Tecumseh

From: North America Product Management Team
To: Tecumseh / Masterflux Authorized Wholesalers and OEM's
Date: January 4, 2017
Subject: Product Update – CASCADE Compressor Series

PRODUCT BULLETIN

Product Bulletin: CASCADE Compressor Series

FIGURE 1.

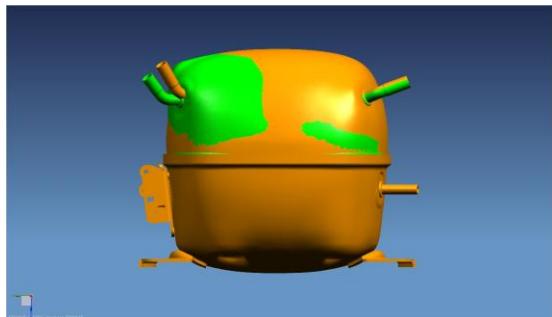
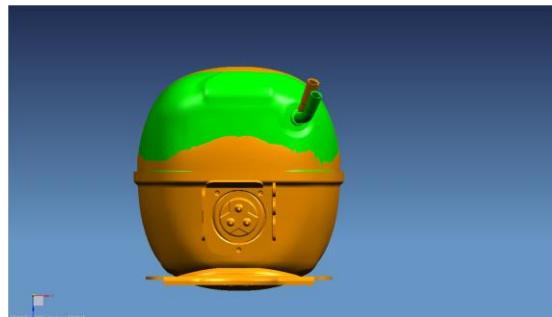
Tecumseh Products Company has made a change to the upper housing on the CASCADE0001/0002 compressor series. The suction tube has been relocated due to this housing change. There have been no internal changes to the compressor nor are there any changes in performance. The figures shown below detail the new housing configuration.
